Flying Spares

UD6089 to RH13253 wiring transposition

Upper Water Tap Actuator

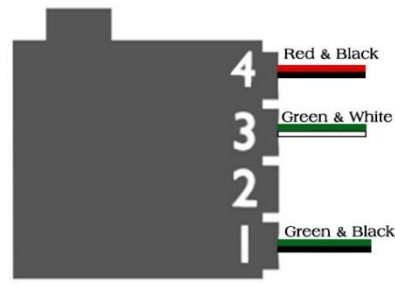
The later RH13253 actuators can be used on the early models. As the early actuators UD6089 are 4 pin and the later actuators RH13253 are 5 pin, there is a small change in how the actuator is wired. Below are the 4 different actuator locations and their respective wiring.
